PRELIMINARY STORMWATER EVALUATION

For
Demarest Pointe
New Hanover County, North Carolina

Prepared for
Middlesound LLC.

Date: June 29, 2020

TITLE
STORMWATER PLAN

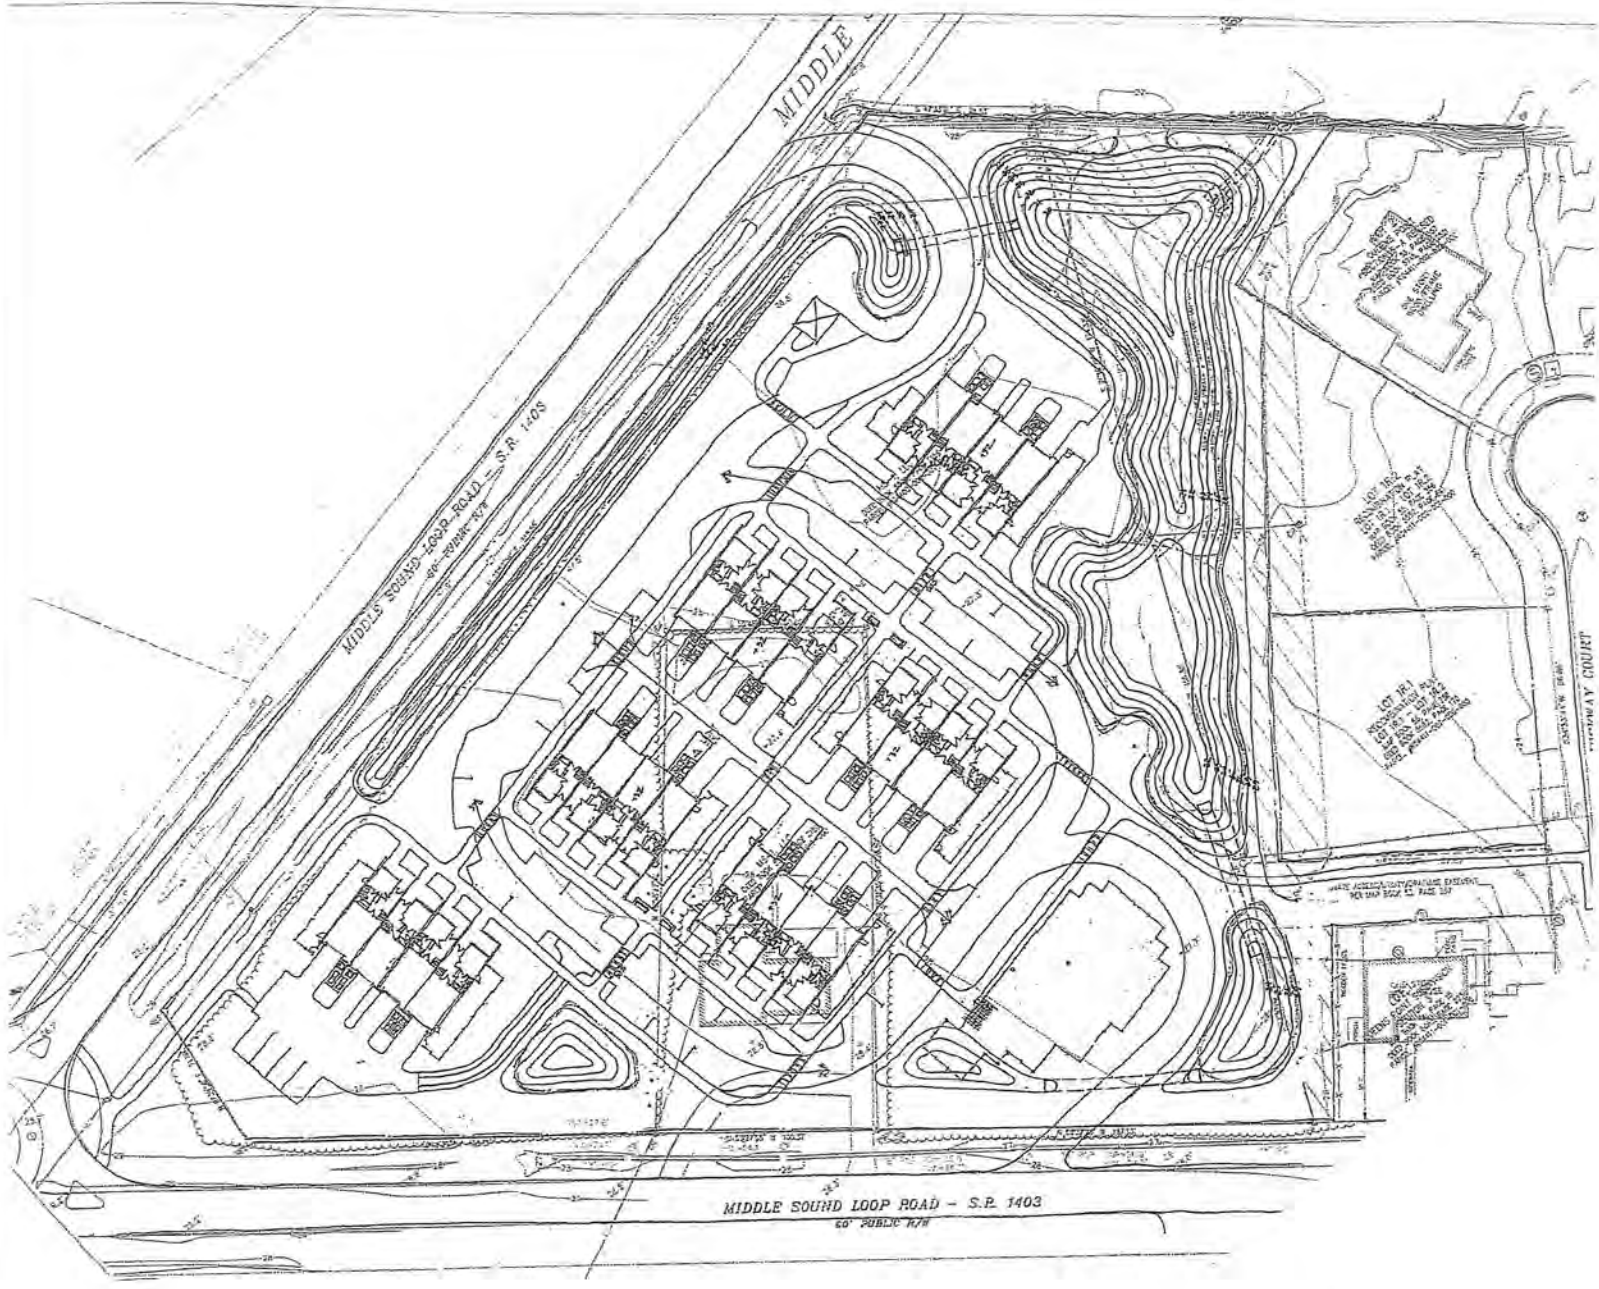
Cape Fear Engineering (CFE) was requested to analyze independently the conceptual stormwater management plan for the proposed Demarest Pointe neighborhood prepared by Middlesound LLC, Scott D Stewart RLA ASLA and was requested to further provide CFE's professional opinion regarding the 5-13-20 CSD Engineering conceptual stormwater evaluation (**attached as Exhibit A**).

CFE performed a preliminary routing analysis of the concept stormwater plan (**attached as Exhibit B**) utilizing Hydraflow Hydrographs modeling software. Model results show that the Demarest Pointe neighborhood is expected to reduce runoff for not only the NHC required design storms but also the 500-year (18.10") and 1,000-year (21.1") storms.

In conclusion, CFE agrees with the overall findings of the 5-13-20 CSD Engineering report. CFE recognizes the Demarest Pointe neighborhood stormwater program will confidently manage a minimum of a 500-year storm event and through the required permitting process, it is feasible to approach or meet attenuation of the 1,000 year storm event.

FEMA Floodmaps

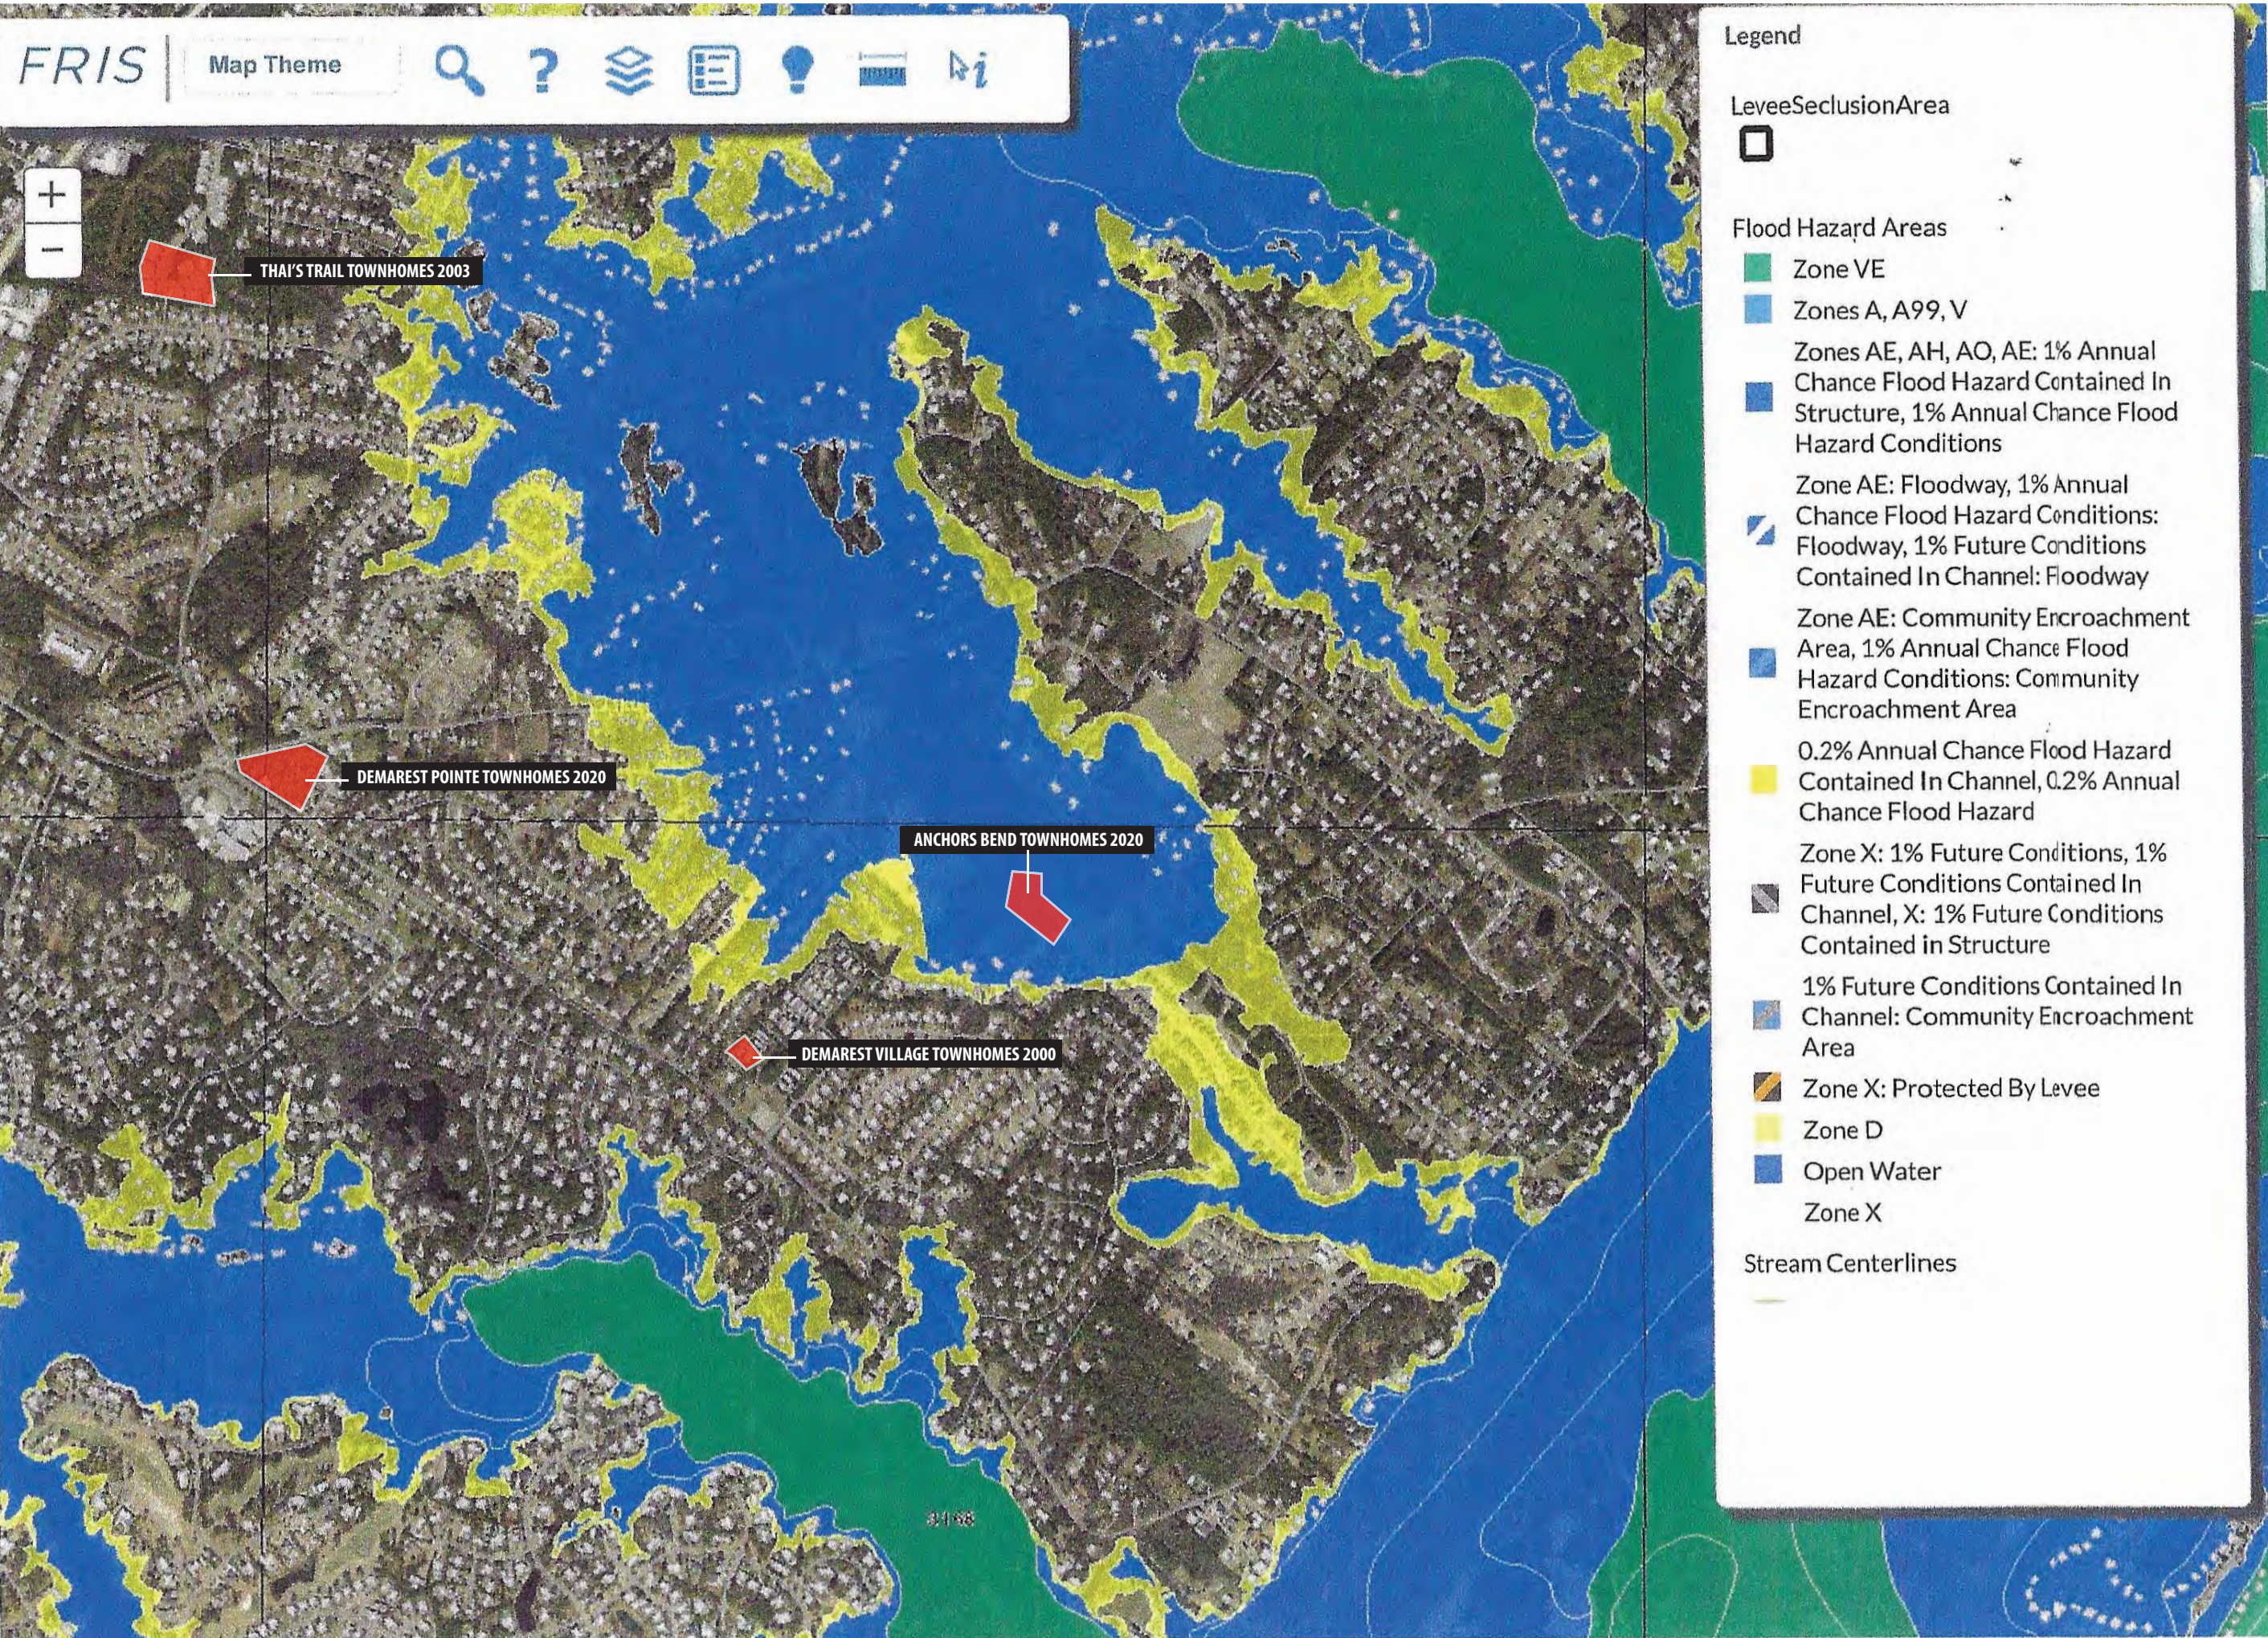
According to FEMA flood maps, **(attached as Exhibit C)** the Demarest Pointe neighborhood is located outside of the 100-year flood zone. Elevations onsite range from approximately +27' to +29'. The nearest 100-year flood zone is located approximately 2,400' to the southeast with a reported food elevation of +13'.

We understand that there have been concerns raised about the Demarest Pointe neighborhood proposal because there has been a history of downstream flooding. Review of FEMA maps and available elevation information shows that the downstream properties are at significantly lower elevations than the proposed Demarest Pointe project site whereas many downstream properties have been built within the 100 year flood zone and experience frequent flooding due to the existing elevations of the homes that were built within the 100 year flood zone of Pages Creek.

Conceptual Water Quality Plan

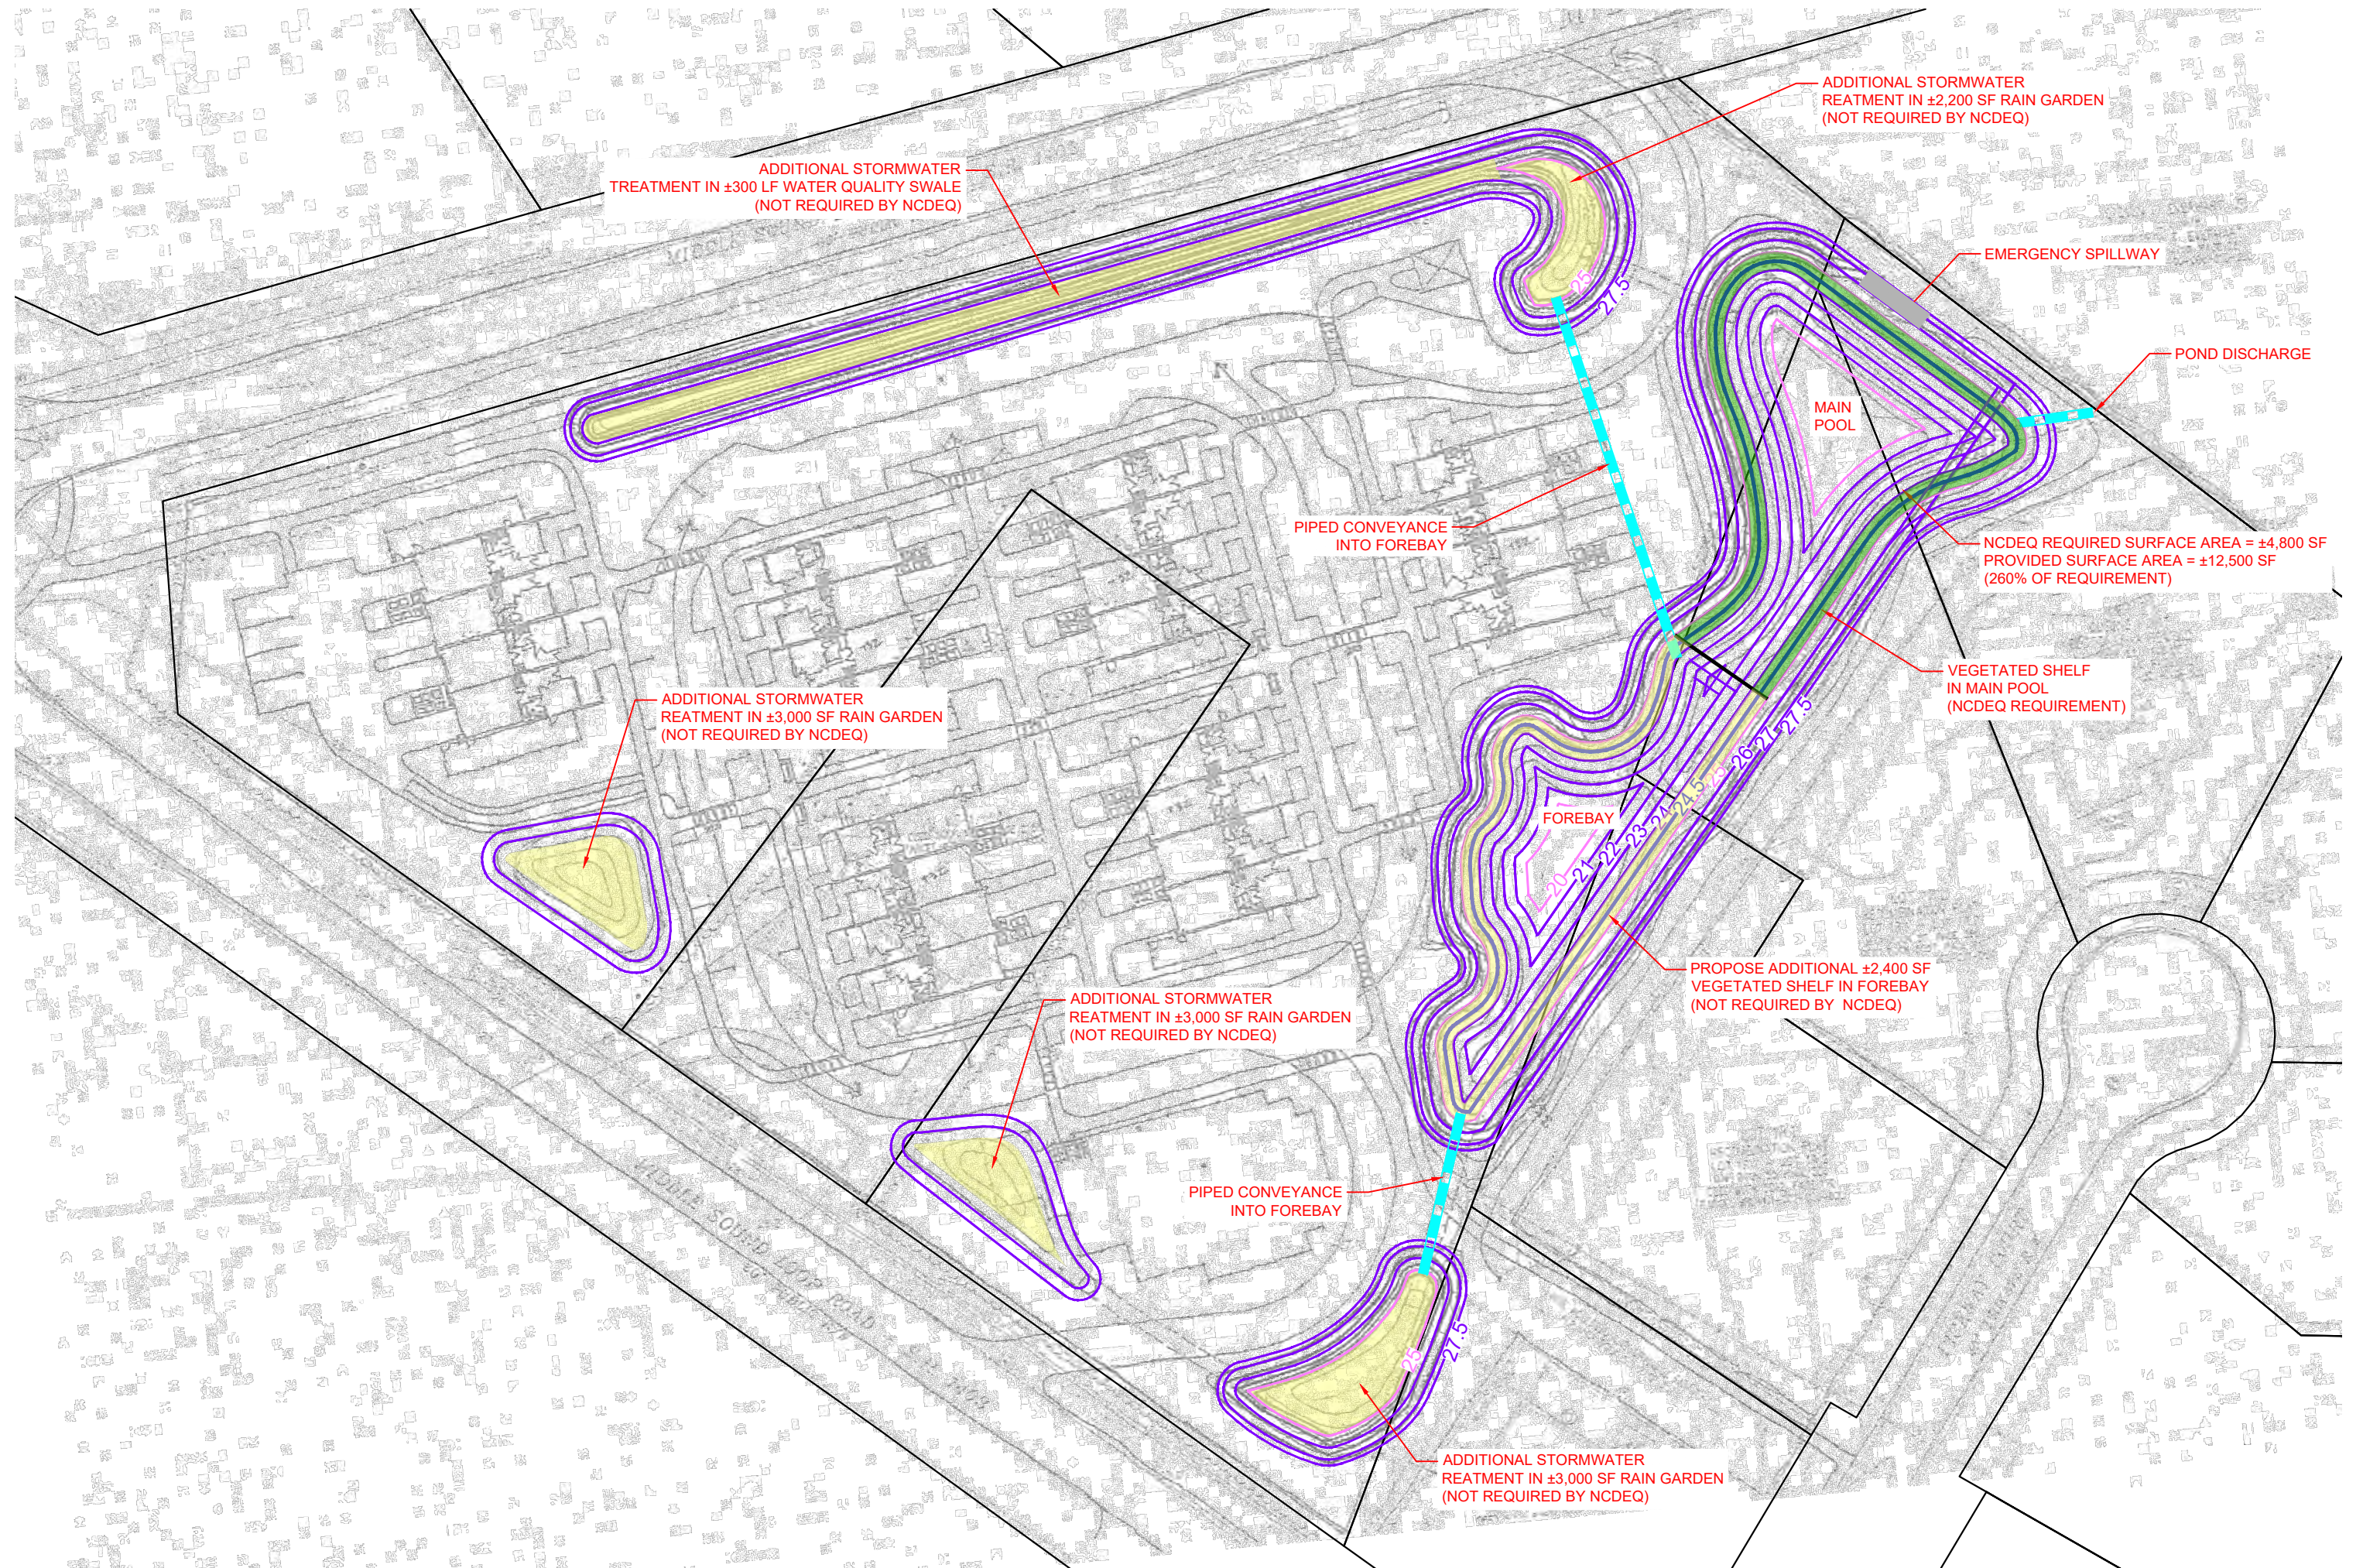
Additionally, the conceptual stormwater plan incorporates additional storage and treatment in four rain gardens and one water quality swale **(attached as Exhibit G)**.

It is the opinion of CFE that the proposed Demarest Pointe neighborhood will provide significantly more stormwater treatment than required by NCDEQ. It is anticipated that the Demarest Pointe neighborhood will provide total treatment volume equal to the more stringent SA waters requirements, though not required. Demarest Pointe will have no adverse or negative impacts on downstream water quality.
